**MINUTES
PLANNING COMMISSION
October 8, 2025**

The Planning Commission of the Parish of Ascension held a Public Meeting on Wednesday, October 8, 2025, at 6:00 p.m. at the Ascension Parish Courthouse, 607 E. Worthey Road, Council Chambers – 1st Floor, Gonzales, Louisiana in a regular session convened.

Subject: Recommended revisions to Appendix V-Drainage.

Exhibit ‘D’

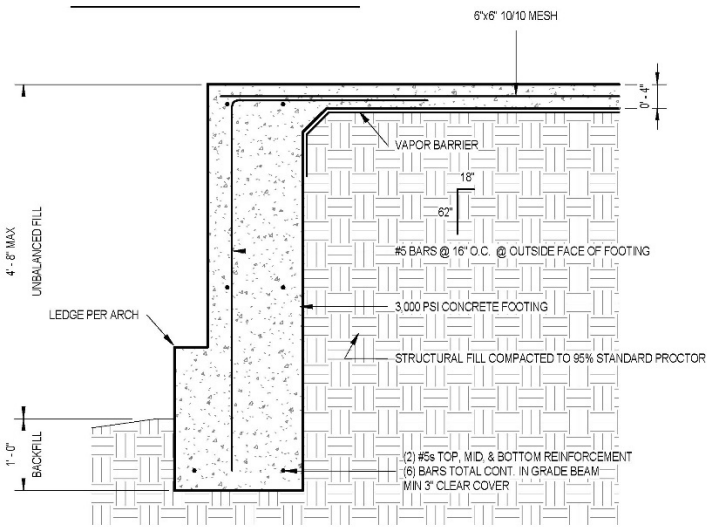
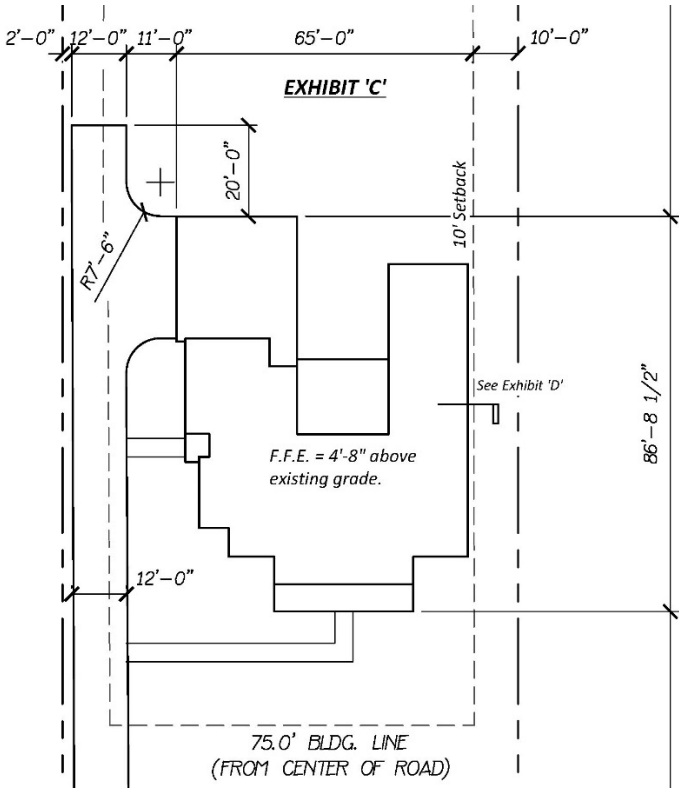
4. Exhibit ‘C’ below, is a plan showing the slab against a 10’ setback line and Exhibit ‘D’ shows the drop brick ledge that allows almost 5’ of fill to be placed within the foundation. Properties with a 5’ setback would be similarly affected.

2. Side slope of fill under the structure(s) shall not be steeper than a three-foot horizontal to a one-foot vertical slope.
 3. Fill shall not be placed within any setback line as per Appendix I – Zoning Tables. Should fill be placed closer than 10' from any property line, it must be contained within the foundation of the building/structure. closer than ten feet to any property line, regardless of setbacks.

Exhibit ‘E’

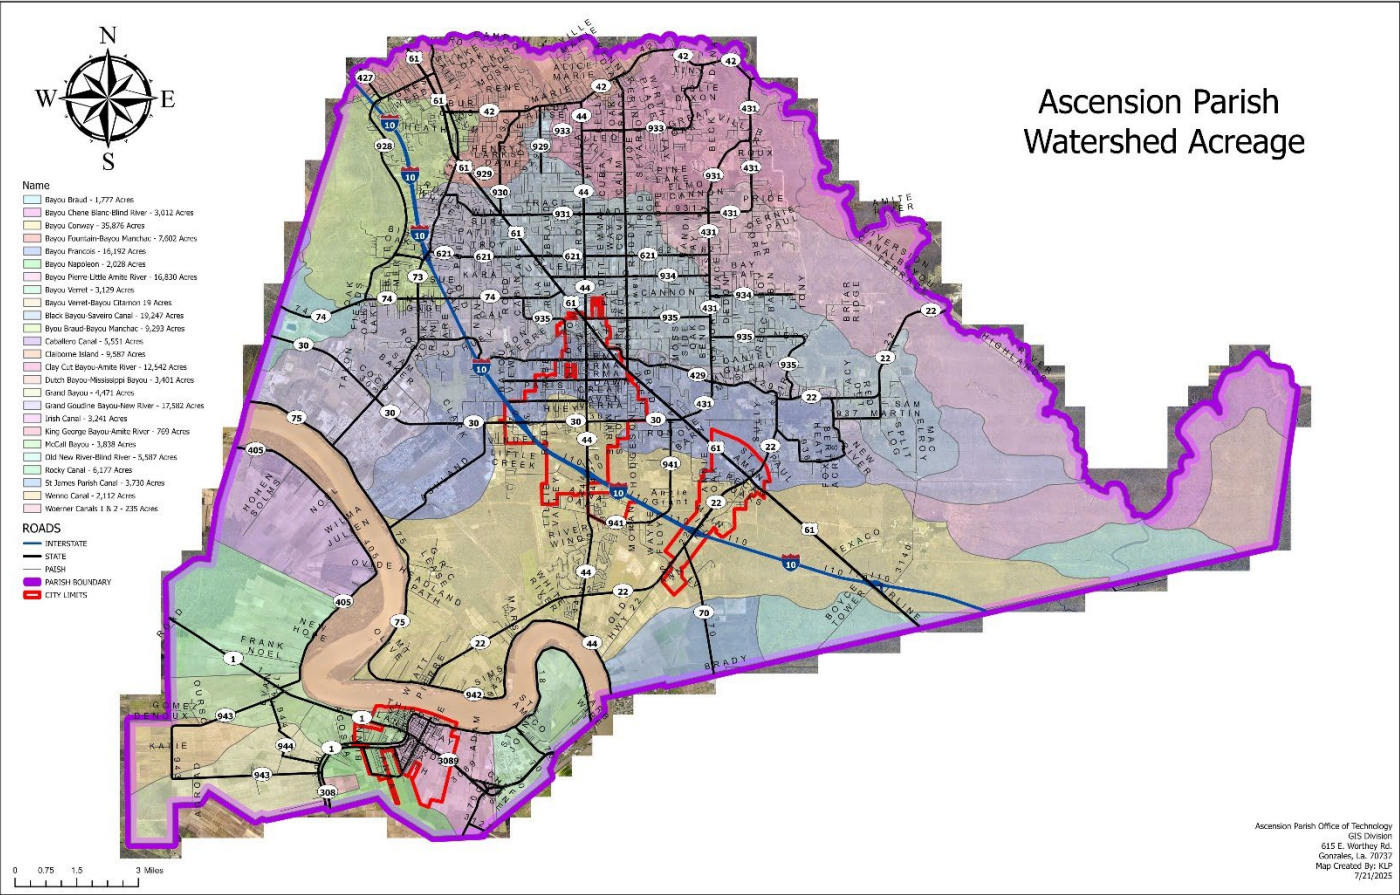
1. This rule previously went off topographical watersheds (Exhibit 'E'). However, since mechanical pumps empty water from multiple watersheds throughout a drainage basin (Exhibit 'F'), it is logical to use the drainage basins as the new limit for each mitigation bank located within that basin.
2. Removing the limiting factor of +/- 1' between the off-site source and the developed source incentivizes individuals who may be thinking of providing engineered fill mitigation from an off-site source to do so as their credits will be valid over a greater area than was previously allowed. This will also provide a more competitive pricing structure for mitigation credits within a drainage basin.

The exhibit below highlights the topographical watersheds on the East and West Bank of the Parish. Taking into account that there are no Drainage Basins on the West Bank, there are 14 watersheds on the East Bank with an average size of 10,960 acres.

4. If the compensating storage is derived from an off-site source (not applicable to section 17-507(C)) that is not a part of the proposed development it shall be located in the same watershed drainage basin as the proposed development, as defined in Section 17-50100. ~~and the base flood elevation at the off-site source shall not be greater than one foot higher than or one foot lower than the base flood elevation of the developed site.~~

Exhibit ‘F’

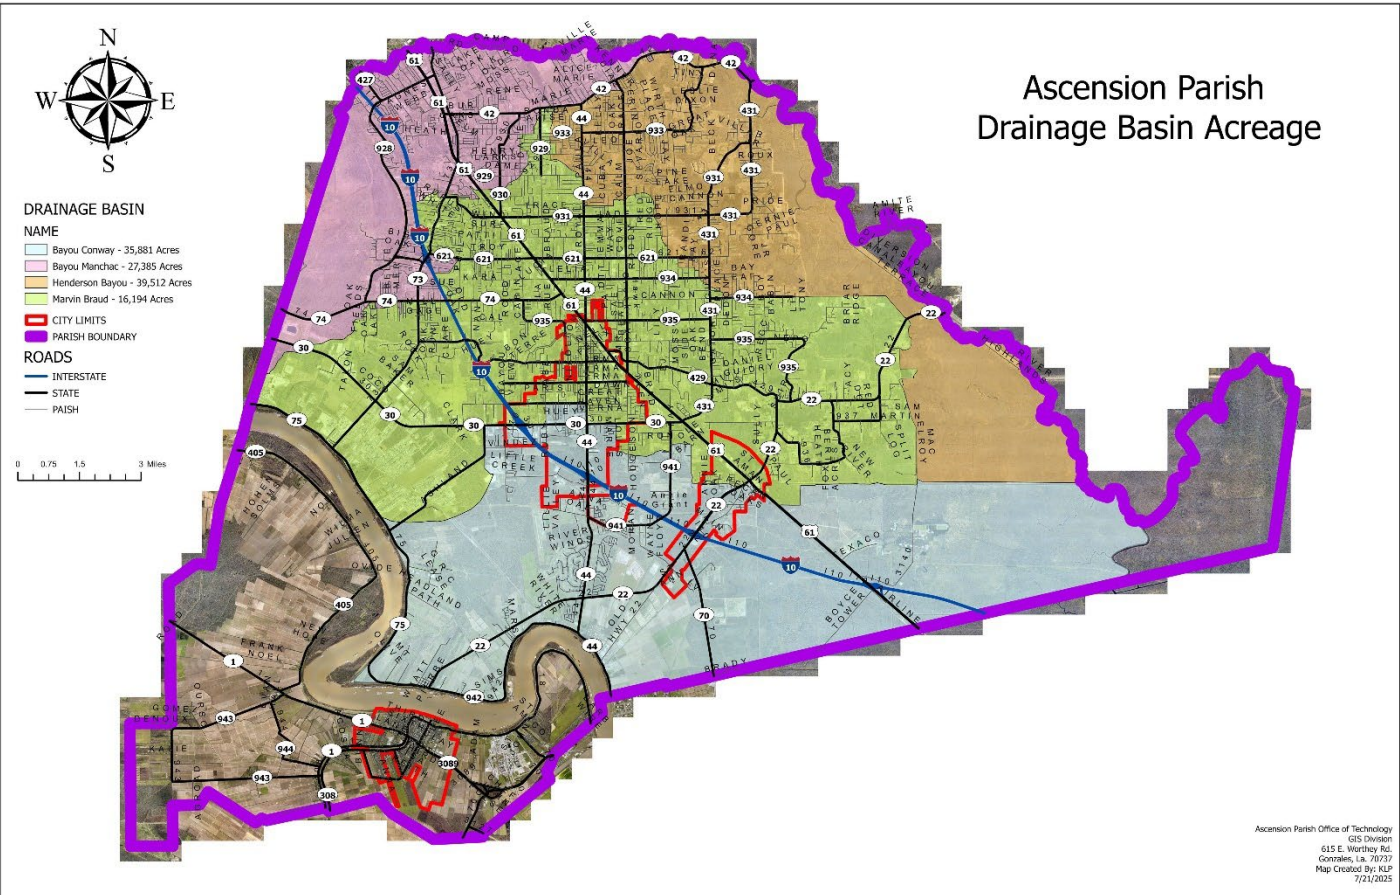
The exhibit below highlights the pump station drainage basins on the East Bank of the Parish. There are 4 drainage basins on the East Bank with an average size of 29,743 acres. This is almost 3 times the average size of the topographical watersheds.

A. Drainage basin means Ascension Parish defined watersheds based on mechanical pump station discharge locations as shown on the official Ascension Parish GIS General Map including, Bayou Manchac, Marvin Braud, Henderson Bayou and Bayou Conway.
